# Technical Comments

## Comment on “Method for Reducing Stagnation Pressure Losses in Segmented Solid Rocket Motors”

## Reply by the Author to R. L. Glick and L. H. Caveny

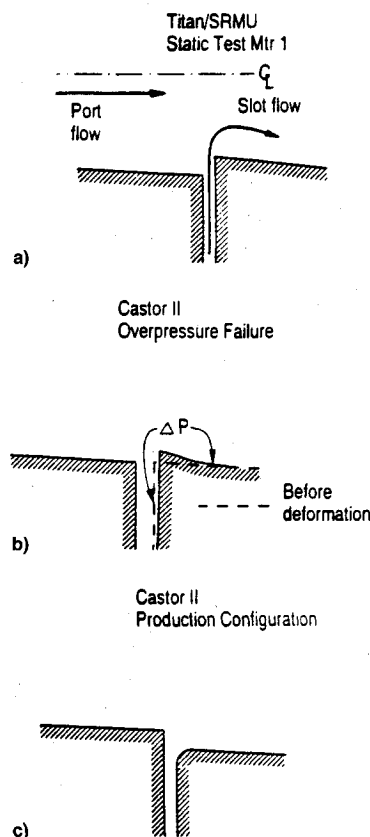
Figure 1 illustrates possible segment arrangements and relates them to real motor situations. In Fig. 1a, port geometry and slot flow effects combine to exacerbate the “aerodynamic” pressure force deforming the downstream grain and the total pressure loss; grain deformation directly aggravates these effects. In Fig. 1b, the deforming pressure force and total pressure loss are initially due solely to the slot/port flow interaction. However, grain deformation directly aggravates the process and Fig. 1b becomes like 1a. In Fig. 1c, total pressure losses may be increased, the aerodynamic pressure force is reduced, and grain deformation does not directly aggravate the deformation until it is large.

Johnston's study did not examine  $\Delta A_{\text{port}} > 0$  arrangements.<sup>3</sup> However, if the slot flow turned and filled the downstep region, free expansion losses would be reduced and *so would mixing losses*! Therefore, total pressure loss minimization may be compatible with Ref. 2 good design practices. Clearly,

In regard to the second point, I would agree with Glick and Caveny that the design change proposed in Ref. 1 will not necessarily optimize an SRM from the standpoint of reducing the initial stagnation pressure loss or reducing the danger of catastrophic grain collapse. The idea in the original Note was that a simple rearrangement of the segments would improve the motor in both of these respects, and that this could be achieved with the propellant segment shapes currently in use.

Concerning their first point, that a coupled flow/structural analysis is required to properly analyze SRM performance, I would also agree with Glick and Caveny on this matter. The fixed grain geometry calculations, for which results were presented in Ref. 1, are only valid if the propellant deformation is small, due either to a stiff (high modulus) propellant or to the nature of the design. And the standard SRM design (Ref. 1, Fig. 1a), which has forward propellant segment corners that jut out into the bore flow and experience large aerodynamic loading, is a design which by its very nature is prone to deformation. In cases where the grain deformation is not small, such fixed geometry calculations can only provide a preliminary assessment of SRM performance. A coupled flow-structural interactive calculation is needed in the final analysis. It should be added however, that my modified design (Ref. 1, Fig. 1b), and Glick and Caveny's alternate design (their Fig. 1c), are both less prone to deformation under the expected aerodynamic loading, as are chamfered (i.e., Ritchey radius) designs.
